# CITY OF ALBUQUERQUE

**RE: Lexus Parking Lot  
4849 Pan American Fwy NE  
Grading & Drainage Plan  
Engineer's Stamp Date: 1/30/25  
Hydrology File: K17D107**

Based upon the information provided in your submittal received 2/6/2025, the Grading and Drainage Plan is approved for Grading Permit and Building Permit. Please attach a copy of this approved plan in the construction sets for Building Permit processing along with a copy of this letter.

GRADING PLAN

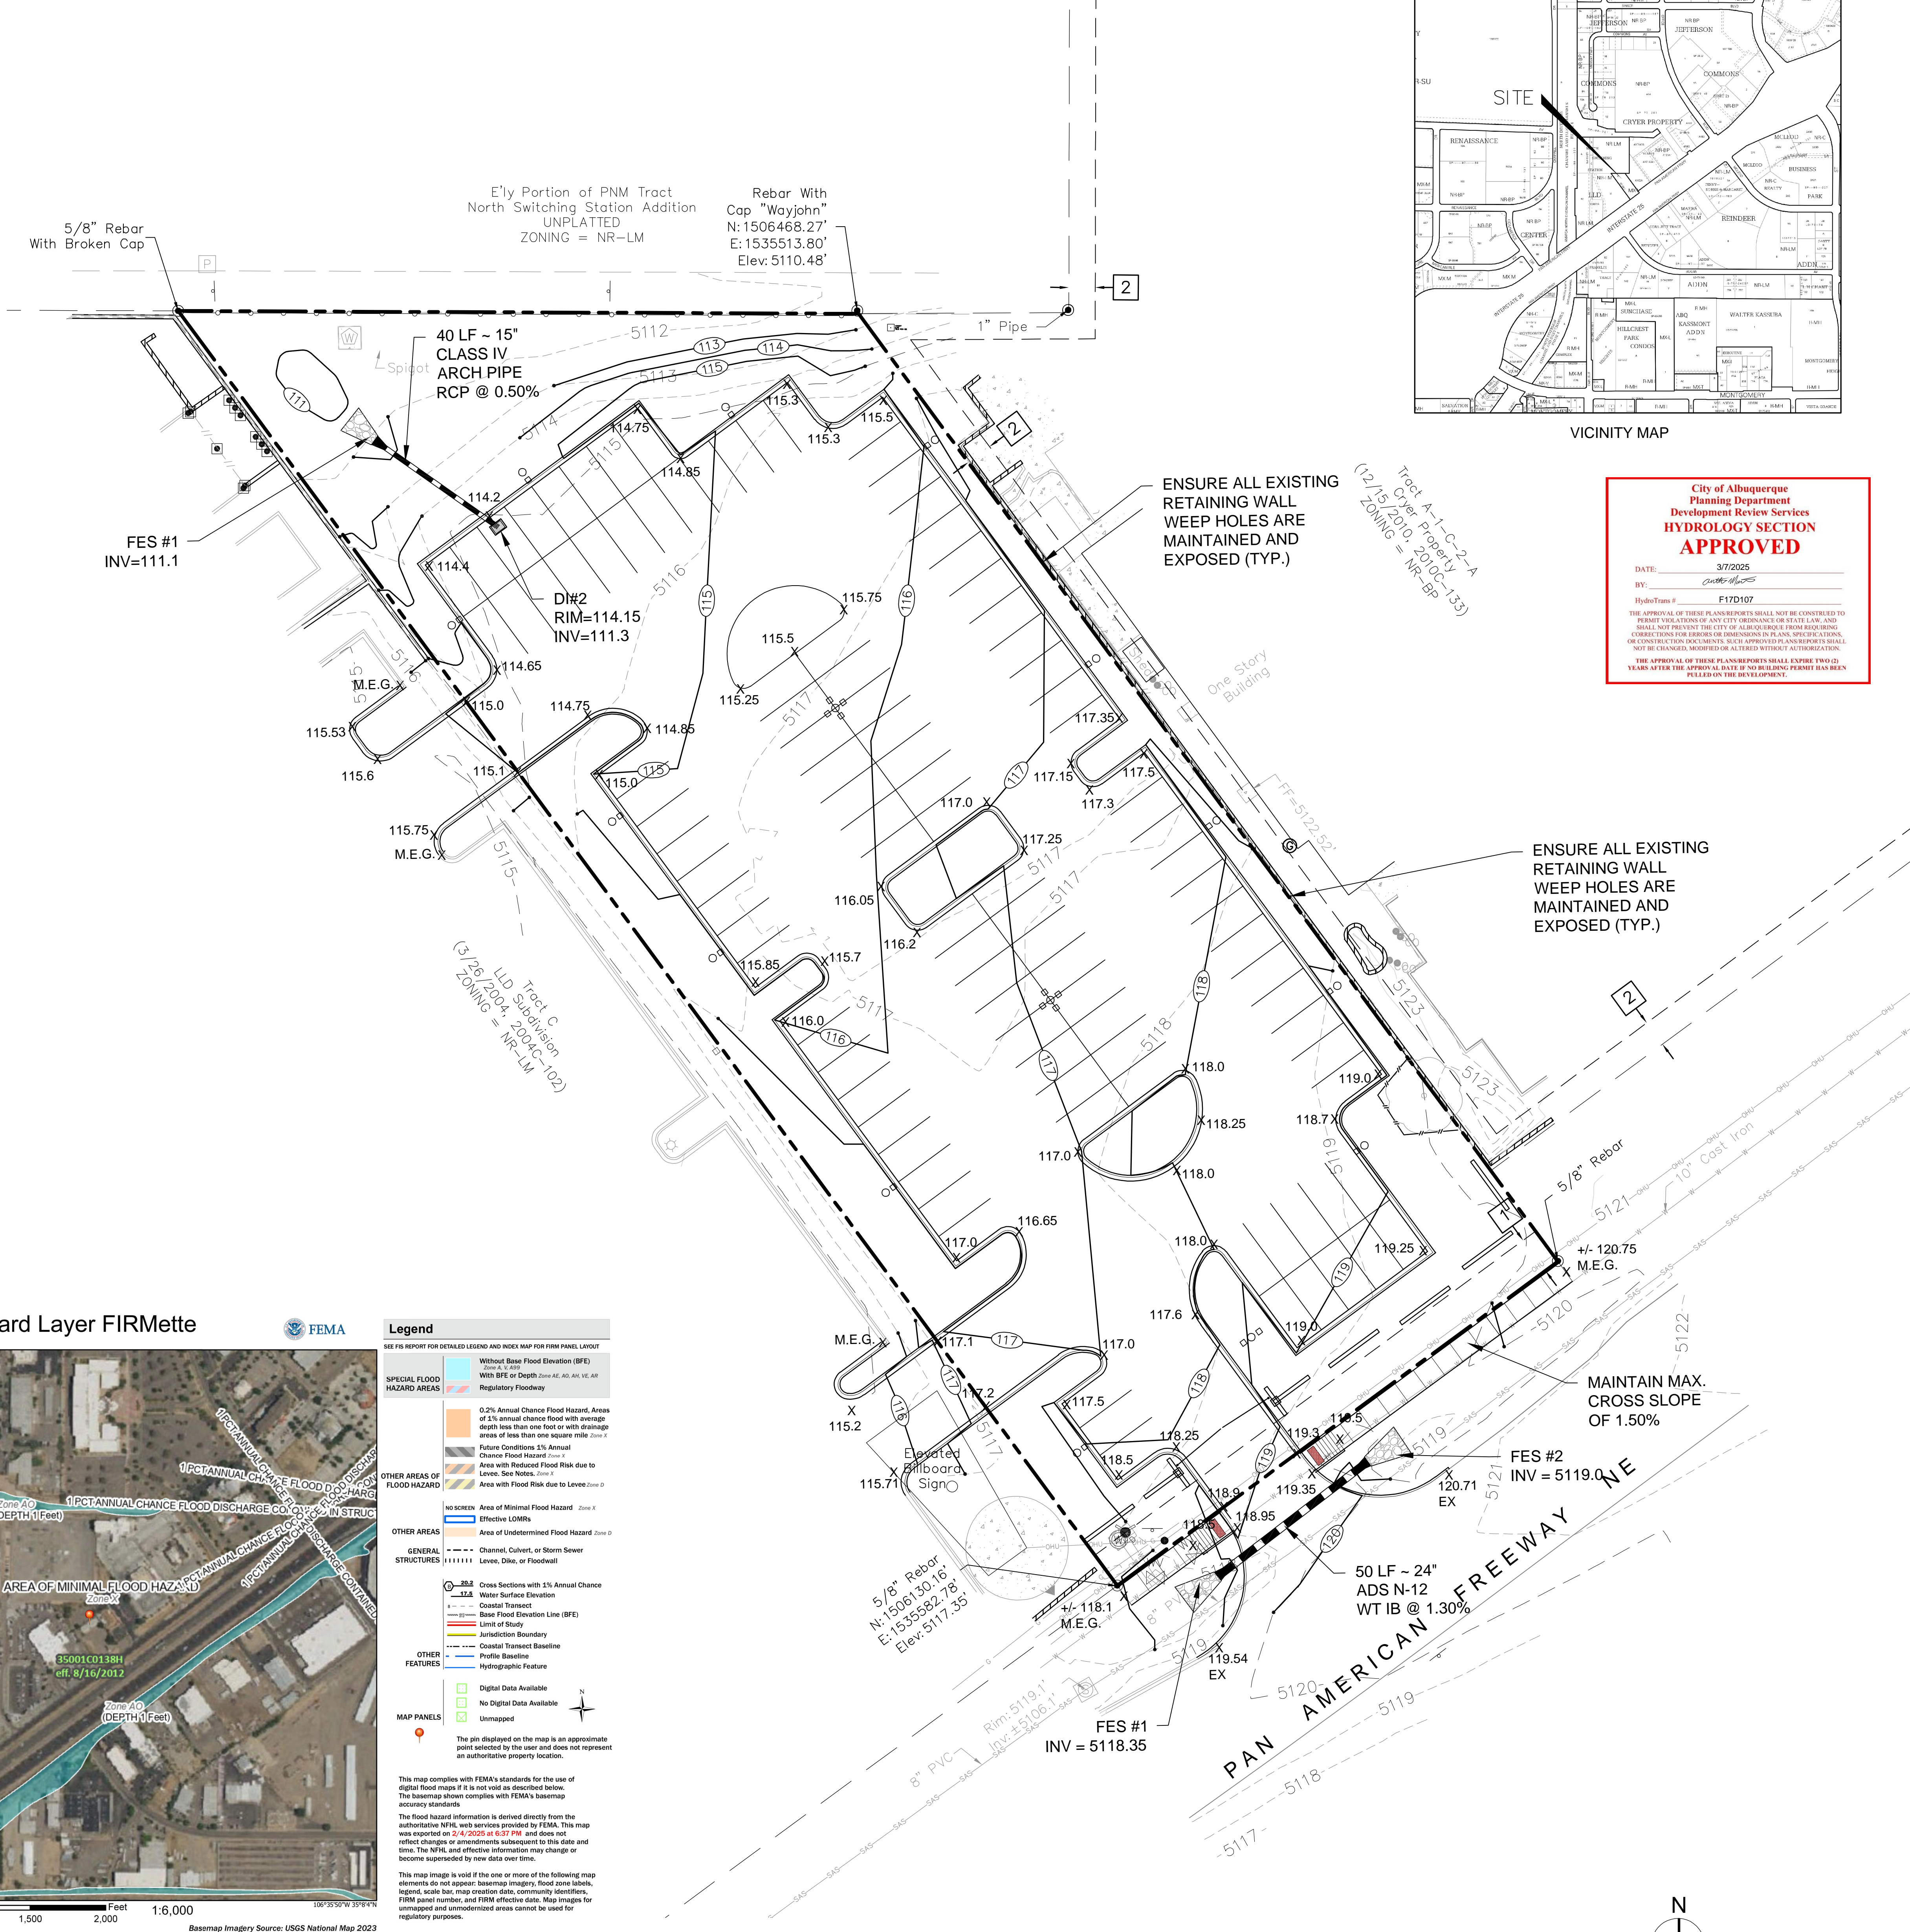
1. Engineer's Certification, per the DPM Part 6-14 (F): Engineer's Certification Checklist For Non-Subdivision is required.
